SUBJECT: SEP TOPIC II-4.D, STABILITY OF SLOPES
BIG ROCK POINT

Systematic Evaluation Program Topic Assessment

Topic: II-4.D - Stability of Slopes

Plant Name: Big Rock Point Nuclear Power Plant (BRP)

FIGURE 1
 SITE PLAN
 BIG ROCK POINT NUCLEAR POWER PLANT

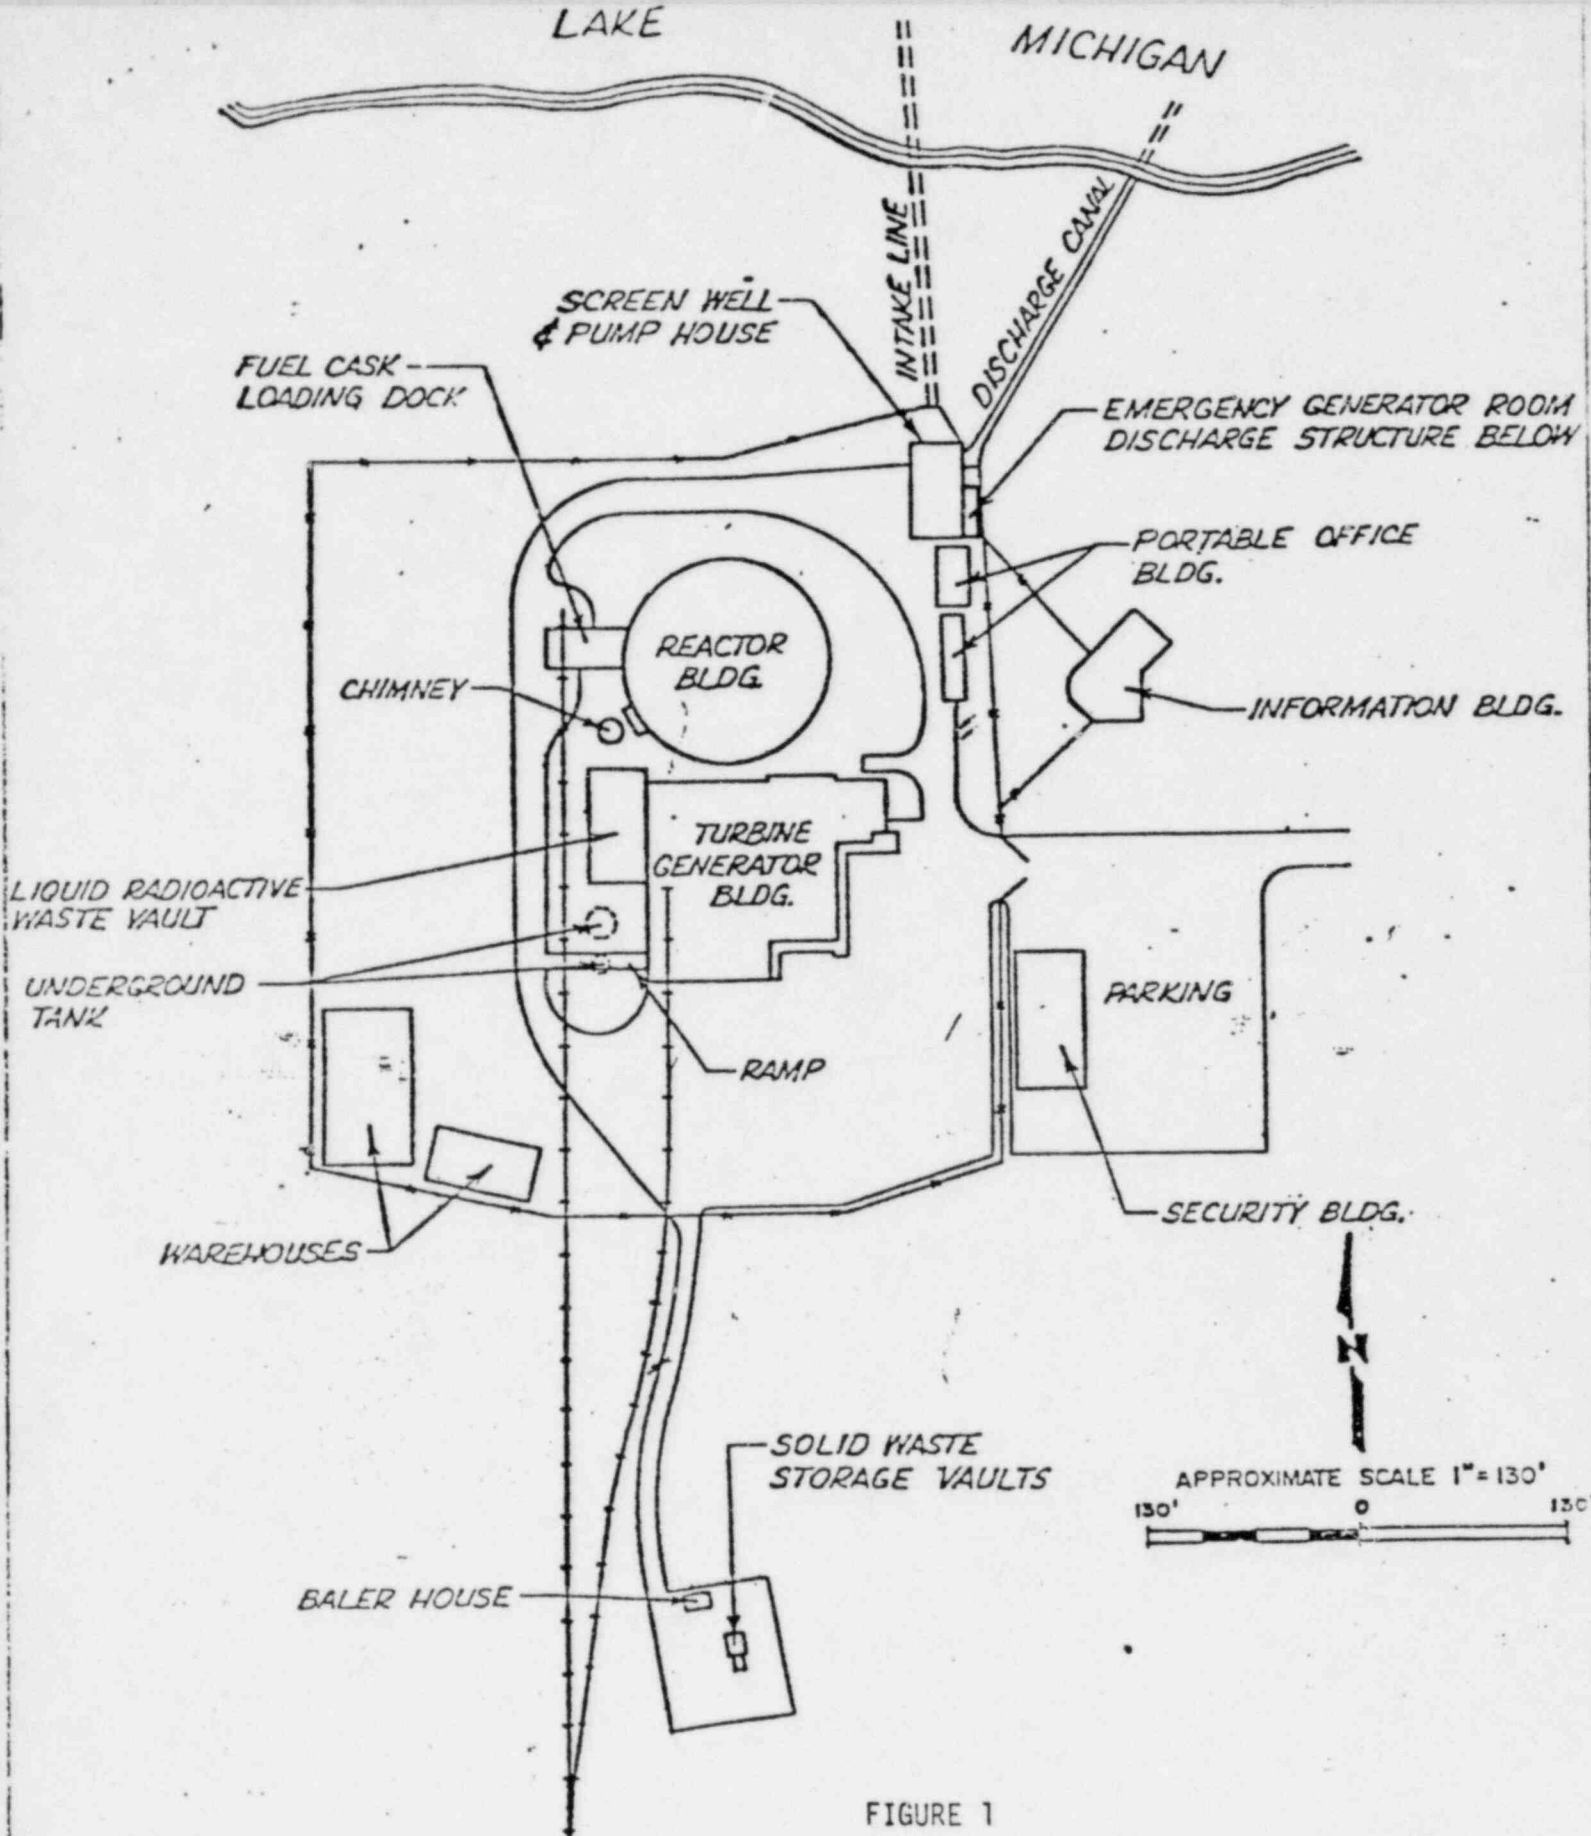
The Big Rock Point Nuclear Power plant (BRP) is located on the eastern shore of Lake Michigan, approximately 4 miles northeast of Charlevoix, Michigan. Figure 1, "Site Plan" shows the general layout of the plant. The plant grade is at elevation 592.5 ft (USGS datum) and the water level of the Lake Michigan varies between elevations 576.0 to 584.0 ft.

The topography at the site varies from level to gently-sloping towards the lake. There are no man-made or natural slopes of any significance whose failure would effect the safety of the plant (References 1 and 2). This was confirmed by NRC staff during a site visit (Reference 3).

The licensee has stated in his Safety Assessment Report (Reference 1), and the staff concurs, that there are no natural or man-made slopes at this site whose failure would effect either the safety of the plant or attaining a safe-shutdown of the plant. The staff concludes that slope stability is not a radiological safety concern at the BRP site.
